***Hydraulic  
Reservoir***

**Baron  
Santiam**

The following information supersedes the information published in the 2003 Baron Owner's Manual on pages 331 and 340 section 10 and the 2003 Santiam Owner's Manual on pages 349 and 358 section 10. Please utilize the information provided henceforth.

The information provided for the Hydraulic Reservoir, Nelson manufacturer is incorrect as shown for the Beaver 2003 Baron and Santiam.

### **Hydraulic Reservoir**

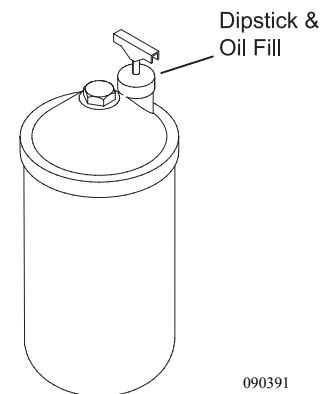
The Hydraulic Reservoir information on pages 10-331 for the Baron and page 10-349 for the Santiam should have following information corrected:

The power steering reservoir with internal filter is located at the rear of the engine. The hydraulic filter assembly, located inside the reservoir, is rated at ten micron\*. The reservoir is filled with Dexron-III® Automatic Transmission Fluid from the factory.

**Filter assembly: Nelson 91085G**

**Element number: 84365A (ten micron\*)**
